**UNIFORM STANDARD DRAWINGS
CLARK COUNTY AREA**

VOLUME I - YEAR 2009 REVISIONS

UNIFORM STANDARD DRAWINGS CLARK COUNTY AREA	
TYPICAL BUS TURN-OUT	
DATE 11-13-08	DWG. NO. 234.1

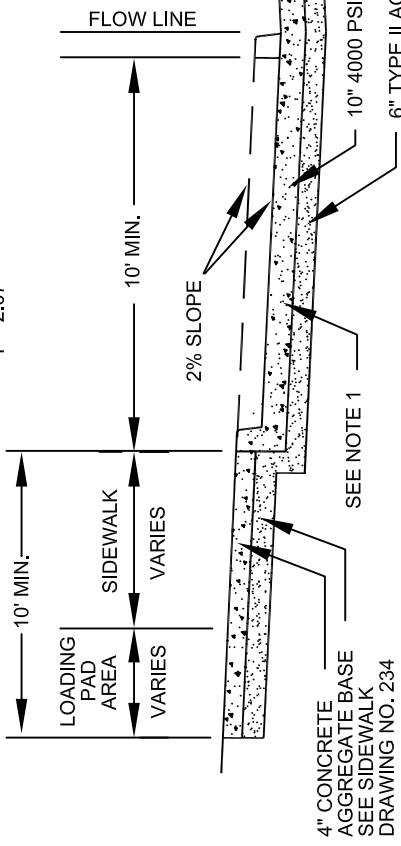
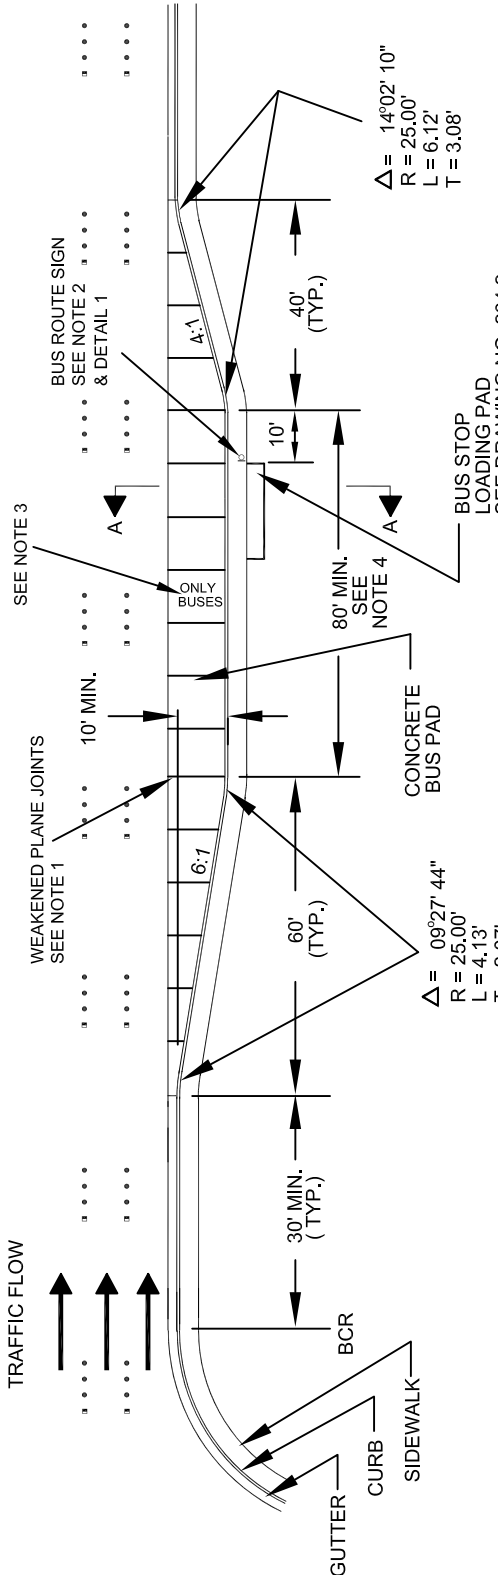
Drawing Number	Title	Nature of Change	Effective Date
234.1	"Typical Bus Turn-Out"	Revision to correct the dimension of sidewalk and loading pad.	1/1/09
234.2	"Typical Bus Stop Passenger Loading and Shelter Pads"	Revision to require that the dedication of additional right-of-way or easement for the loading pad and variable height curb at the back of sidewalk ramp be granted to the local entity.	1/1/09

SPECIFICATION REFERENCE		UNIFORM STANDARD DRAWINGS CLARK COUNTY AREA	
302	AGGREGATE BASE	TYPICAL DOUBLE BUS STOP PASSENGER LOADING AND SHELTER PADS	
501	CONCRETE		
502	CONCRETE STRUCTURES		
		DATE 11-13-08	DWG. NO. 234.2A

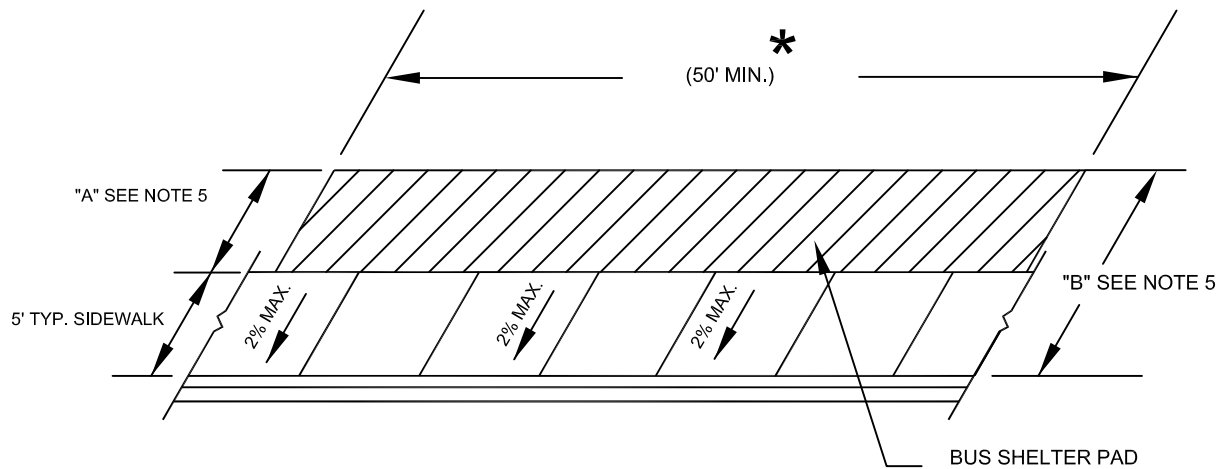
234.2A	"Typical Double Bus Stop Passenger Loading and Shelter Pads"	Revision to require that the dedication of additional right-of-way or easement for the loading pad and variable height curb at the back of sidewalk ramp be granted to the local entity.	1/1/09
412A	"Type C-D Modified Drop Inlet"	Revision to clarify the closed lid specification.	1/1/09
503A	"Method A for Flexible Pipe Trench Backfill - Paved Areas"	DELETED , See 503AF	7/1/09
503AB	"Method A/B for Rigid Pipe Trench Backfill - Paved Areas"	DELETED , See 503AR	7/1/09
503AF	"Method A for Flexible Pipe Trench Backfill - Paved Areas"	Revision to clarify the requirement for the use of controlled low strength material (CLSM). (Formerly 503A)	7/1/09
503AR	"Method A for Rigid Pipe Trench Backfill - Paved Areas"	Revision to clarify the requirement for the use of controlled low strength material (CLSM). (Formerly 503AB)	7/1/09
503B	"Method B for Rigid and Flexible Pipe Trench Backfill - Paved Areas"	Revision to clarify the requirement for the use of controlled low strength material (CLSM).	7/1/09

1. SIDEWALK RAMP MAY BE REQUIRED TO BE CONSTRUCTED IN THOSE LOCATIONS WHERE THE BUS STOP WOULD OTHERWISE BE INACCESSIBLE AS DEFINED BY THE AMERICANS WITH DISABILITIES ACT. SEE DRAWING NO. 235, SHEET 4 OF 4 FOR SIDEWALK RAMP DETAILS.
2. ADDITIONAL RIGHT-OF-WAY OR EASEMENT IS REQUIRED FOR BUS SHELTER PAD AND VARIABLE HEIGHT CURB AT BACK OF SIDEWALK RAMP, AND SHALL BE DEDICATED TO THE LOCAL ENTITY.
3. AGGREGATE BASE AND CONCRETE FOR LOADING PAD SHALL BE THE SAME AS REQUIRED FOR SIDEWALK. SEE DRAWING NO. 234.
4. BUS SHELTER PAD CONNECTION TO DETACHED SIDEWALK CONDITION SHALL BE DETERMINED BY THE ENTITIES.
5. "A" = 10', "B" = 15' UNLESS BUS TURNOUT IS CONSTRUCTED PER STANDARD DRAWINGS 234.1 OR 234.3, THEN "A" = 5', "B" = 10'.
